EEG-68
DOE/AL/58309-68

EVALUATION OF THE WIPP PROJECT'S COMPLIANCE WITH THE EPA RADIATION PROTECTION STANDARDS FOR DISPOSAL OF TRANSURANIC WASTE

March 1998

Figure 2. Overall Mean of Normalized Releases for Modeling of increased solubilities using Nesquehonite and 'No Backfill' Values compared to CCA values.

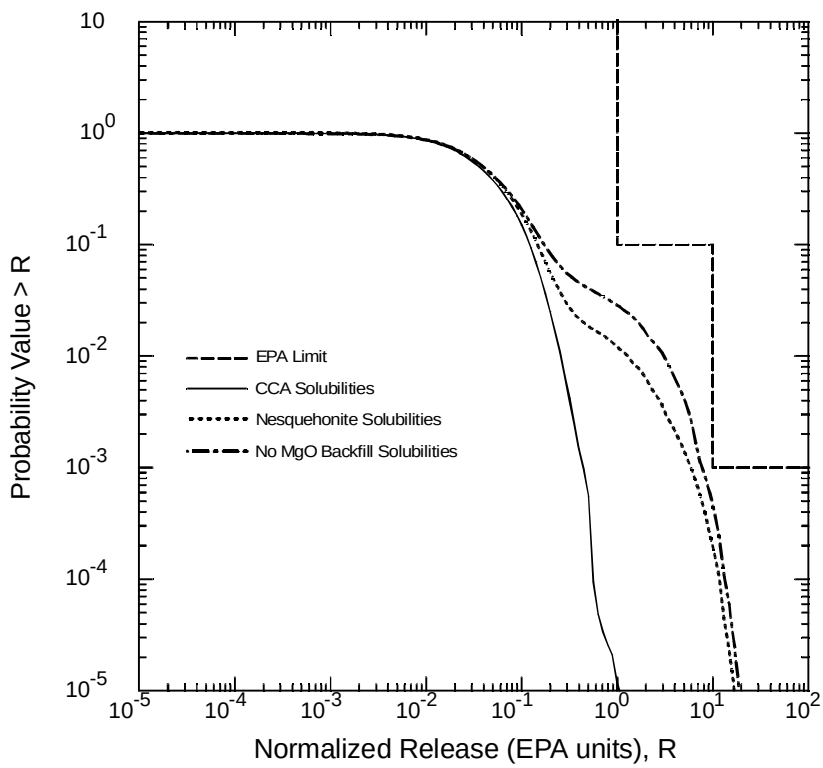
The results of running new solubility values can be seen in Figure 2. The figure shows the overall mean of all processes combined as they relate to compliance. In addition, the PAVT direct brine releases were run with the slightly higher CCA solubilities. The most distinct feature of the figure is the shoulder of the high solubility models that extend below the 10^{-1} probability limit. The "shouldering" is the effect of increased releases due to the direct brine release. Since the Pu+4 and Th+4 (although minor) solubilities increased over 5 orders of magnitude, the release due to this mechanism is expected to increase significantly as well. For example, the CCA median value for +4 actinide solubilities in Castile brine was $6x10^{-9}$ M. If one assumes 100 m^3 of Pu^{239} brine, then it is expected that the release is $2.5x10^{-5}$ EPA units. If the solubility is increased by $10^{5.23}$ as seen in Table 1., then it is expected that 4.24 EPA units are released to the accessible environment. Therefore, the CCDF for higher solubilities would be closer to the EPA limit.

The consequences of higher solubilities, as seen in Figure 2 are quite high. The overall mean

Figure 3. Contiguous Failed Volume as a Function of Increasing Waste Permeability for Different Waste Strengths With Initial Repository Pressure of 14.5 MPa.

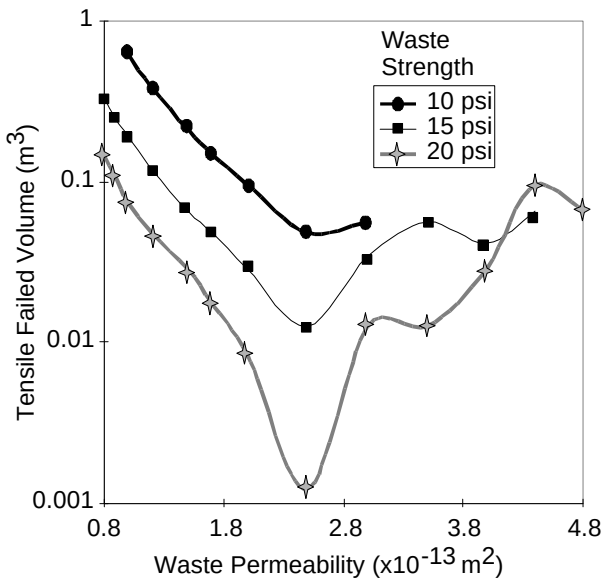
The reported failed volumes outside the range for the Base Case are extremely high, resulting in as much as 22.5 m^3 for a permeability of $0.5x10^{-13}$ m^2 due to the cascading affect of multiple zone failure. The geometry of the borehole cavity was discretized and solved on a hemispherical coordinate system. The layers of the hemisphere were kept to a minimum (0.01 meters) to avoid instability. When the waste in the borehole fails, it is assumed that the whole layer fails, and peels off like an onion skin. When the code calculates a large failed volume, as in the case with $0.5x10^{-13}$ m^2 permeability, the effect is several layers peeling off in one time step, cascading until an equilibrium is reached with the high pressure gradient that existed at a longer time period. It is assumed that when the cascading effect is exhibited, the results become meaningless.

Figure 3 shows some interesting results as the waste permeability increases. All the waste strengths tested showed an exponentially decreasing failed volume, up to a permeability of 2.5×10^{-13} m^2. Permeabilities above this value cause larger failed volumes than values below it. The upper limit on permeability shows that the code is reliable to 2.5×10^{-15} m^2 for waste strengths that were measured in the report by Hansen et al. (1997) and initial repository pressure of 14.5 MPa. The lower permeability limit is 1.0×10^{-13} m^2 for 10 psi waste strength, and decreases to 0.8×10^{-13} m^2 for waste strengths of 15 and 20 psi.

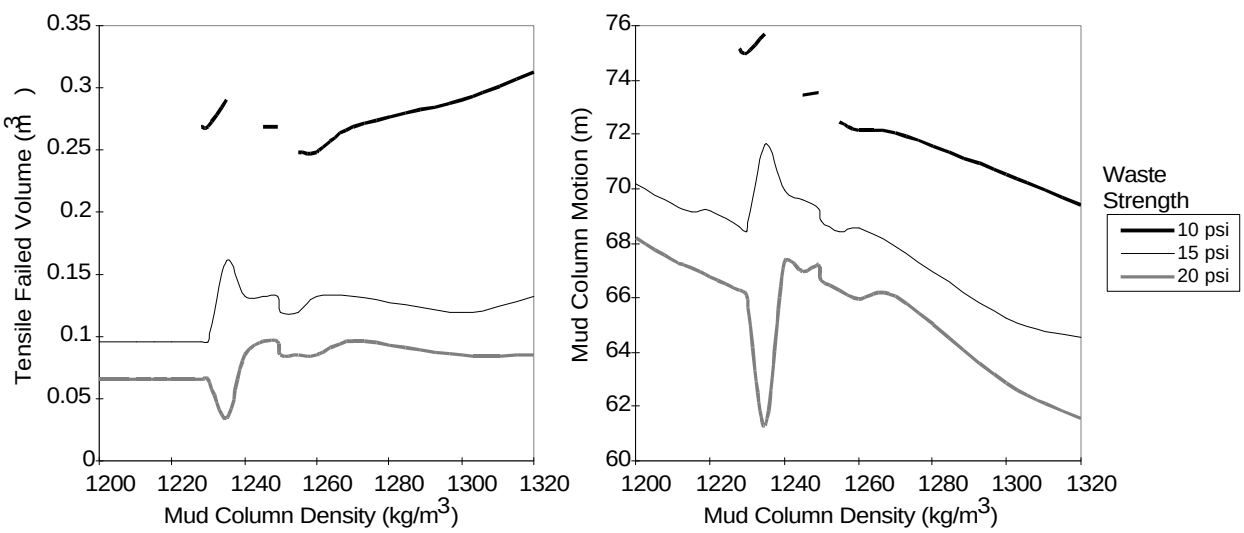
Figure 4 shows the results of varying the parameter from 1200 to 1320 kg/m^3 for a 10 second simulation and an initial repository pressure of 14.8 MPa. The figure shows three curves of different waste strength, with all other parameters remaining the same as used in the Base Case simulation. The most outstanding feature of Figure 4 is the disjointed curve of failed waste (left) and mud motion (right) of the 10 psi tensile waste strength simulation. The code had trouble calculating failed waste for mud densities below 1228 kg/m^3, resulting in the cascading affect described above. The code also had trouble at 1240 and 1250 kg/m^3, and if results were plotted for these densities (failed waste and mud motion), sharp spikes would exist in the curve.

For the higher waste strengths (and subsequently lower repository pressures) of 15 and 20 psi, the mud density simulations were able to calculate failed volumes for all density values investigated. However, the results seemed almost as unreliable as the lower waste strength. Though a trend can be seen in the failed volume and mud motion, variances from those trends are high. Both graphs in Figure 4. show trouble with densities between 1230 to 1270 kg/m^3.

Figure 7. Failure Volume (m^3) vs Time (s) for Different Waste Permeabilities. The results are from GASOUT with the option of 'failed material removal' turned off.

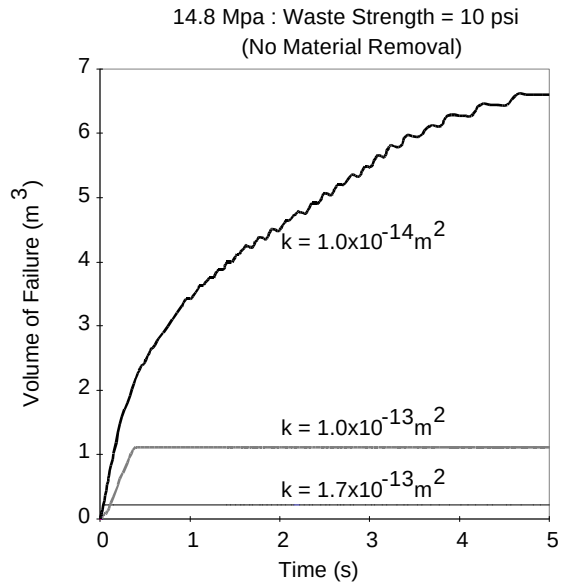
For an extreme example of the above analogy, Figure 7 shows radial distance of potential failure at permeabilities of 1.7×10^{-13} and 1×10^{-14} m^2 for pressures at 14.8 MPa without material removal. Potential failure was extrapolated from the effective stresses that would exist in non-failed material. The repository pressure was set at 14.8 MPa and waste strength at 10 psi for the experiments in Figure 7.

The figure clearly shows that when permeability is lower than assumed in the CCA then releases will be higher than assumed from the investigation in Hansen et al. (1997). The maximum radial failure at a permeability of 1×10^{-14} m^2 is 1.17 m, equating to an uncompacted spalled volume of 6.6 m^3. It is believed that when permeability is even lower than the lowest value presented in Figure 7, the releases could be higher. However, the code has difficulties with oscillations in pressures at lower permeabilities, and confidence in results is low.

The results of Figure 7 must be kept in context. When material is not removed during the pore pressure calculations (and subsequently total overburden stress), the code does not redistribute values at the new boundary. Instead, the pore pressures decrease in that region, hence lowering the possibility of new failed material. Therefore, Figure 7 actually underestimates the potential effect of failure, and higher volumes will result if the material is removed. These calculations are not possible with GASOUT, with reasons explained from the sensitivity analysis with the code.

Figure 11. Effective Radial Stress As A Function Of Radial Distance For The EPA's Air Drilling Analysis.

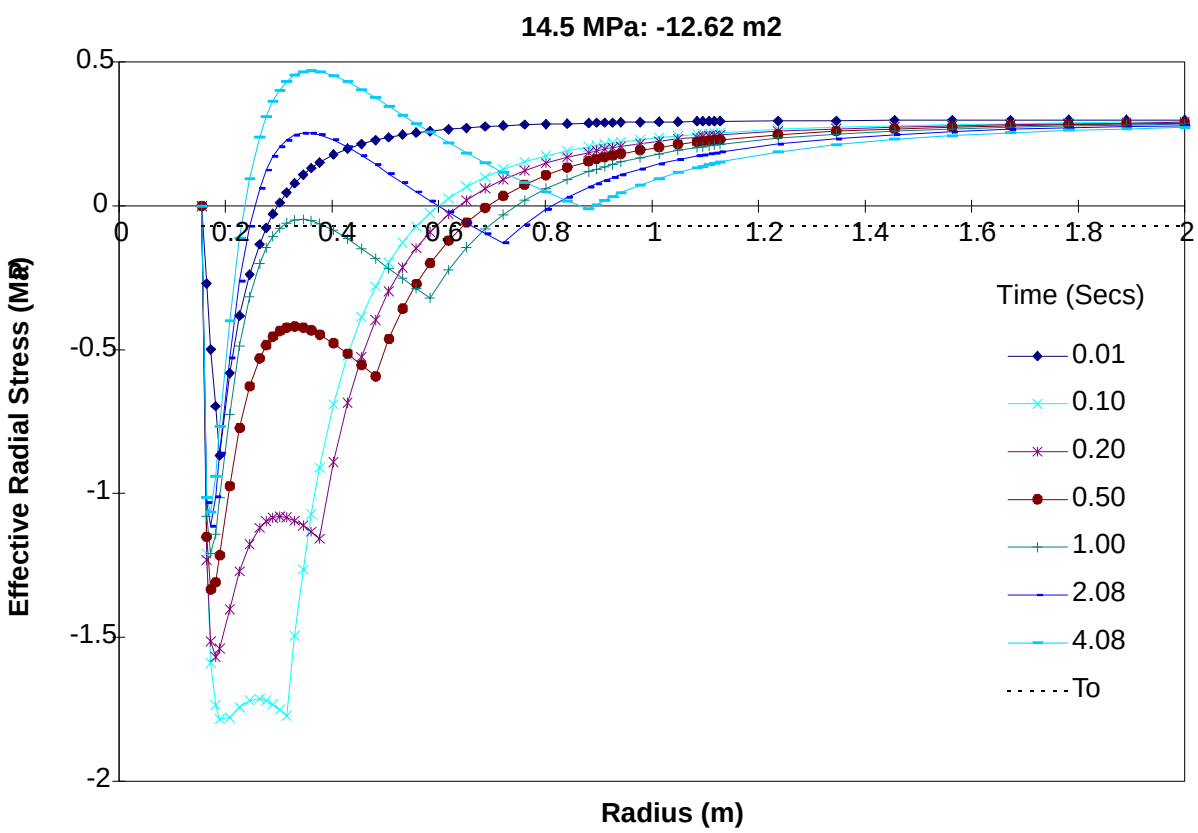
The results of air drilling from the EPA's analysis at WIPP is reproduced here in Figure 11. The figure shows effective stress versus radial distance within the repository at several times during the simulation. The EPA judged failure in this figure by estimating the point at which the effective stress is less than the strength of the material (indicating high pore pressure). This point is at 1 second from the beginning of the simulation, with a radial failure distance of 0.69 m (1.4 m^3 of uncompacted waste). After 1 second of simulation time, the pore pressure in the waste near the cavity begins to decrease, and the effective stress moves upwards (increases positively) towards the region of higher total stress.

Intuitively, the results shown in Figure 11 would raise questions about the behavior of the system. Why does the effective stress sharply decrease from 0.01 seconds to 0.1 seconds then gradually rise throughout the remainder of the simulation? Does the system stop predicting failure after 1 second? What is the effect of tangential stresses in the waste? How does the system respond to varying repository parameters? All of these questions are relevant to the understanding of the Quasi-Static model and to the prediction of stresses in the waste from an air drilling event.

Figure 12. Effective Stress, Total Stress, and Pore Pressure Profiles in the waste at three independent times from the EPA's Analysis of Air Drilling.

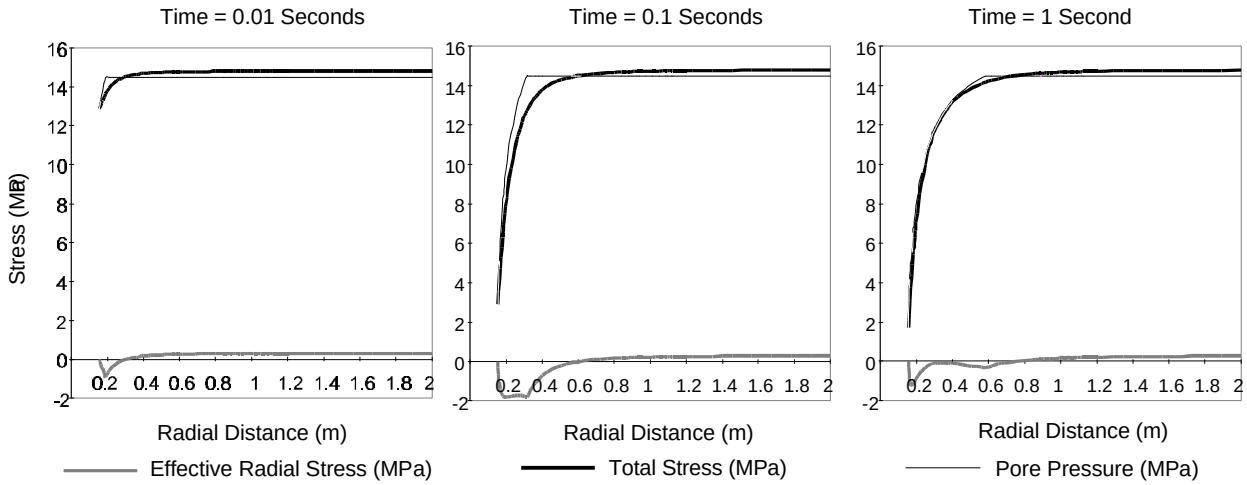
The effective stress is simply the difference in the calculated total stress and calculated pore pressure. Figure 12 shows the relationship between these quantities for three separate times for the EPA's analysis of air drilling. The left plot shows the first time step, at 0.01 seconds from time of intrusion. One can see immediately that waste failure occurs due to a slightly higher pore pressure, with the radius of failure being 0.27 m. The relatively large failure at this time is due to the unsmooth function of the pore pressure in the waste, which carries over to the effective stress. The same can be seen the two other plots of 0.1 and 1 second from intrusion time. The effects of the unsmooth pore pressure profile average out as the time from intrusion increases, but is one the reasons for increase in effective stress at later times.

The code also only approximates the pore pressures in the repository by assuming steady flow. As seen in Figure 12 (above), the steady flow assumption causes the pore pressure profile to be unsmooth. This characteristic, when combined with total stress of the overburden rock, produces oddly varying effective stresses in the waste. This shows that the code produces unreliable results for an air drilling scenario. When effective stresses are compared to the results of a code that calculates the time-dependent flow and pore pressures (Figure 13, above), the effective stresses are much lower (higher in the negative direction) than the Quasi-Static model at early times. Beyond the first couple of time steps, the code starts to be less accurate, and pore pressures begin to decrease in waste that should have been removed.

Figure 13. Effective Radial Stress As A Function Of Radial Distance Using GasOut For The Air Drilling Analysis.

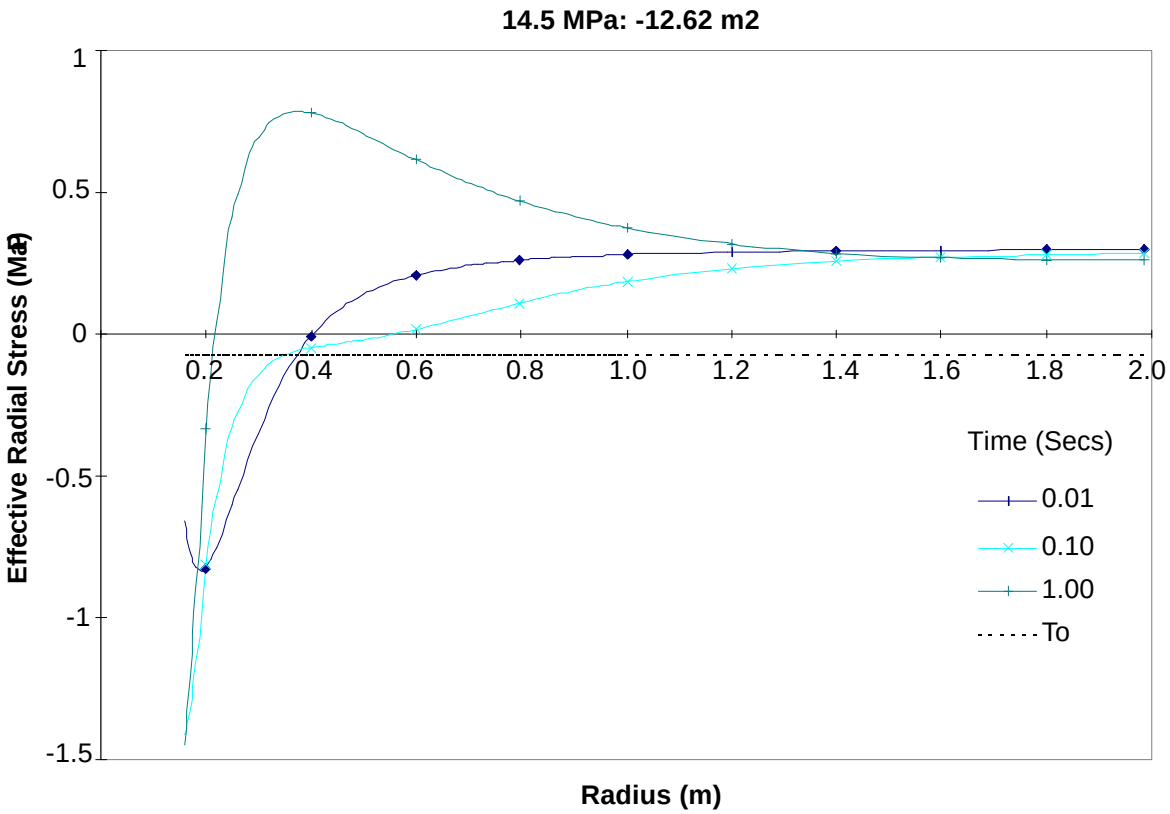
Though the difference in pressures between the two curves is slight, it would have a significant impact on the effective stresses and potential releases. For Figures 1 and 3 above, the pore pressures artificially decrease from the flow of gas in material that should have been removed. Therefore, the judgment of waste failure from Figure 11 leads to false confidence by underpredicting waste failure.

Figure 14. Yield Potential for EPA Air Drilling Analysis. The Figure Represents Equation 2 (above) vs. Radial Distance. Yield Will Occur When the Potential is Greater than Zero.

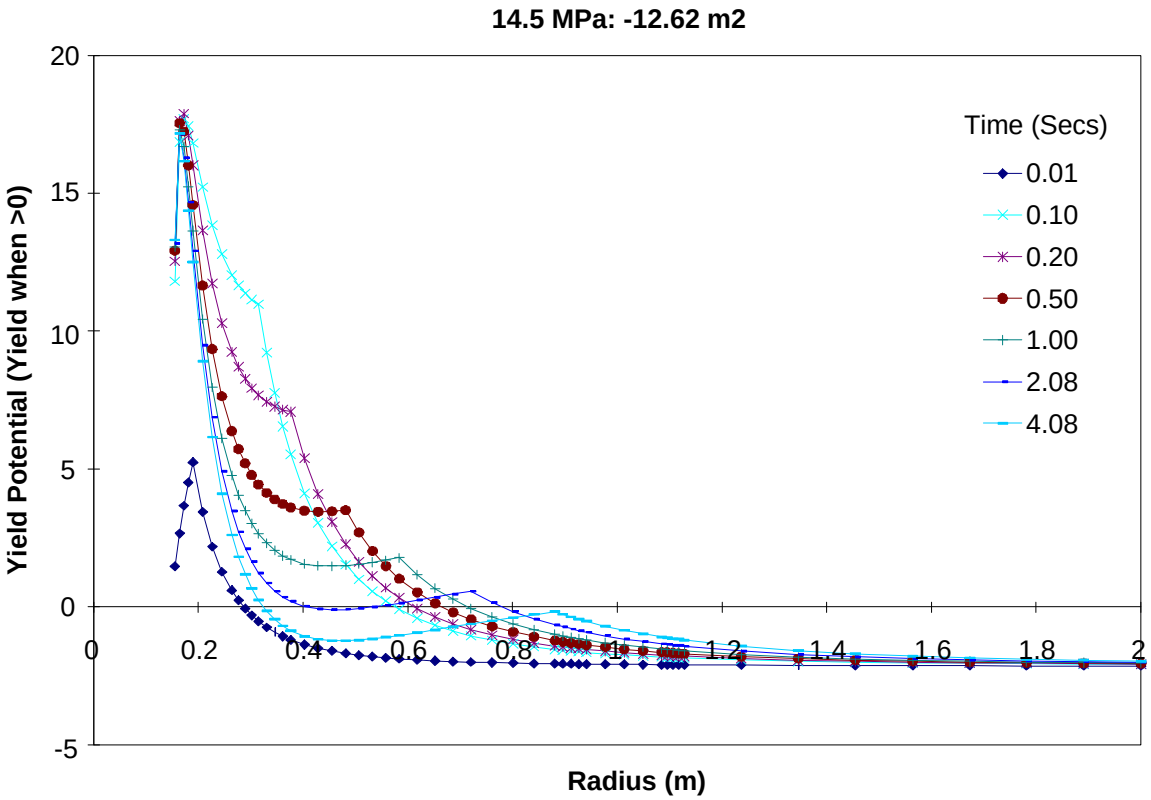
Figure 14 shows the results of Equation 2.5-2 plotted against radial distance. The first observation is that there is potential for yield out to 2 seconds from the time of intrusion. The yield crosses the axis at approximately 0.8 m, resulting in an uncompacted volume of 2.1 m^3. This is an increase of 33% from the initial estimate stated in the EPA's analysis. The curves also seem to be highly influenced by the discontinuity in pore pressure calculations, and can be seen in Figure 14 by the second peak in the curve as radial distance increases. When compared to the yield potential calculated from GasOut, which calculates a smooth function of pore pressure, the limit for yield is 0.7 m at 0.1 seconds from intrusion (as compared to 0.6 m from the Quasi-Static model). After this time the yield is essentially zero.

Figure 15. Effective Radial Stress As A Function Of Radial Distance For An Increased Pressure For The Air Drilling Scenario.

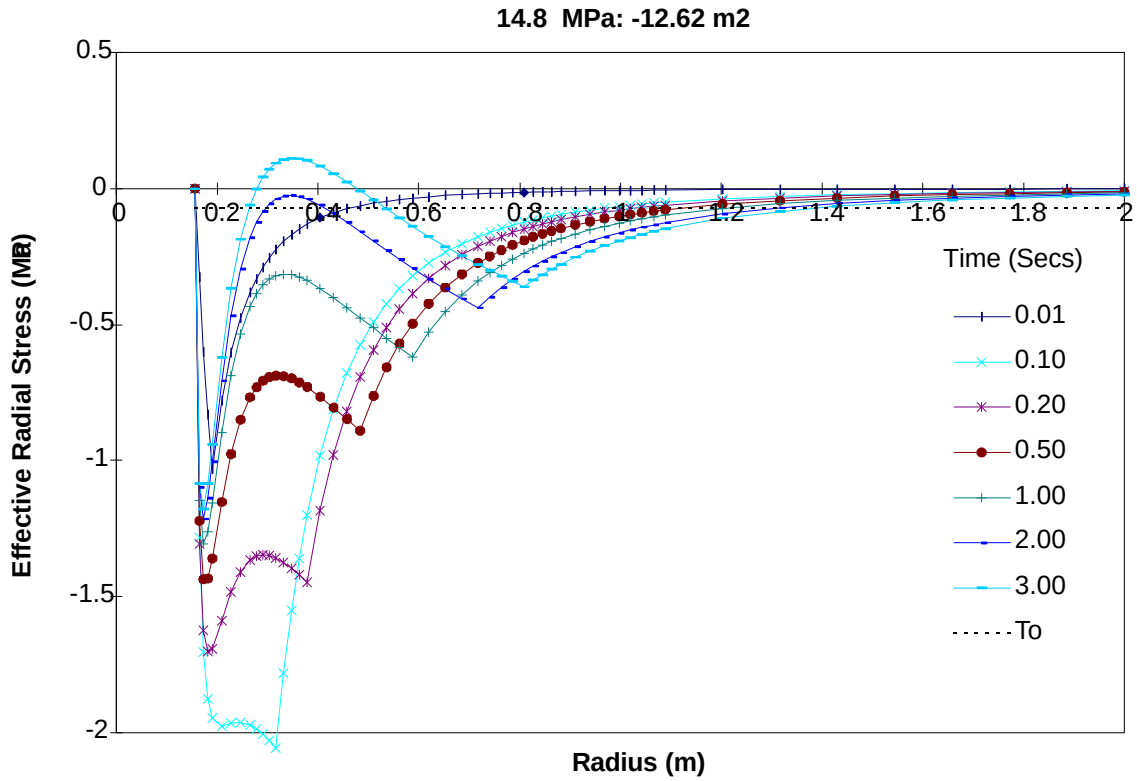
To demonstrate the response of the model to different input assumptions, Figure 15 shows a simulation in which the repository is increased from the nominal 14.5 MPa that was used in the EPA analysis to 14.8 MPa. The higher pressure is the maximum pressure that the repository will

sustain for long periods of time, and is the lithostatic pressure of the overburden rock. If gas pressures are above lithostatic, the weak stratigraphic layers will fracture until sufficient energy is released and the pressure returns to the minimum fracturing pressure. The results of Figure 15 are astounding. The figure shows that a nominal increase in pressure will significantly increase potential releases. At 1 second after initial intrusion, the radial distance of failure is 1.22 m (7.58 m^3 of uncompacted waste). Although not shown, the waste will continue to fail during the entire 9 second simulation, in which the radial distance increases to approximately 1.65 m (19.1 m^3 of uncompacted waste). These volumes are greater than the 4.0 m^3 maximum calculated in the CCA, and perhaps would have an impact on the CCDF calculations if air drilling scenarios were considered in the CCA.

Fig. 19. Comparison of Approved Injection Pressures For Salt Water Disposal Well Versus Oil Field Water Flood Wells Near WIPP.

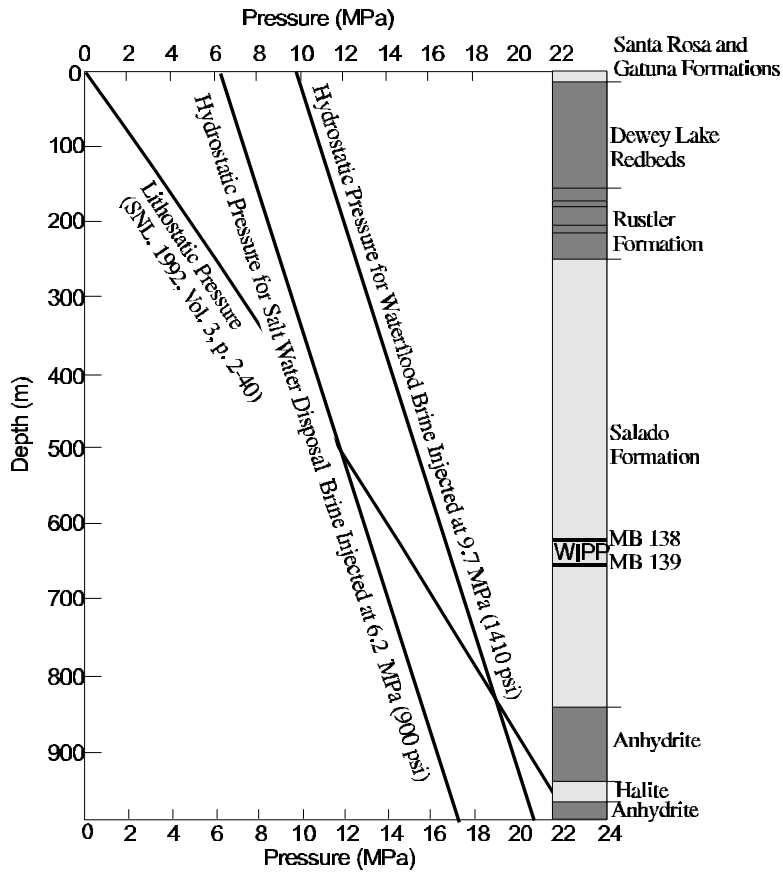
WIPP. Figure 19 compares the maximum approved disposal pressure for two wells one mile to the east of the WIPP Site. EEG is not suggesting that either of these wells are leaking. But EEG notes that in the event of a leak near WIPP current approved salt water disposal pressures are not sufficient at the repository horizon to exceed the lithostatic pressure. Only the a leak in the waterflood well would be of concern to the repository. This is an inherent result of the greater vertical distance to the oil producing horizons. The DOE and EPA rationale appears to be more appropriate for the more shallow oil and gas reservoirs in the Vacuum Field area and the Rhodes Yates area and not suitable for the WIPP area. Presumably, carbon dioxide for enhanced oil recovery would be injected into the deeper oil producing zones and at sufficient pressures to maintain a miscible displacement. Hence, given the observation above, EPA can not conclude that the salt water disposal well analyses captures the CO_2 flooding scenario.

Fig. 20. Solution Mining of Brine and Natural Gas Storage Wells.

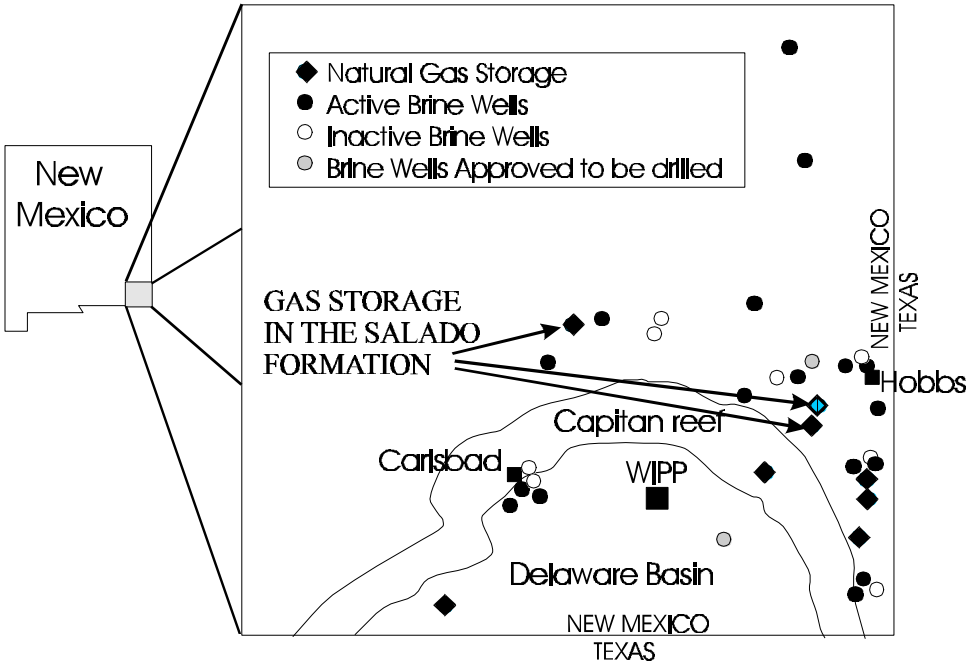
As shown in Figure 20, there are three solution mining operations for brine production near the city of Carlsbad area and at least 16 miles from the WIPP site. EPA mentions only one about 14 miles from the WIPP Site. Furthermore, EPA does not discuss the trend towards drilling brine production facilities closer to WIPP. Brine well BW-26 has been approved for production from the Salado Formation. The solution mining operation would be located between Jal and Carlsbad to meet the demand for drilling brine. The well was approved to remove salt from the Salado formation which lies between 1500 to 2300 feet deep. The subsidence calculations provided by DOE were for a facility that is 583 feet deep.
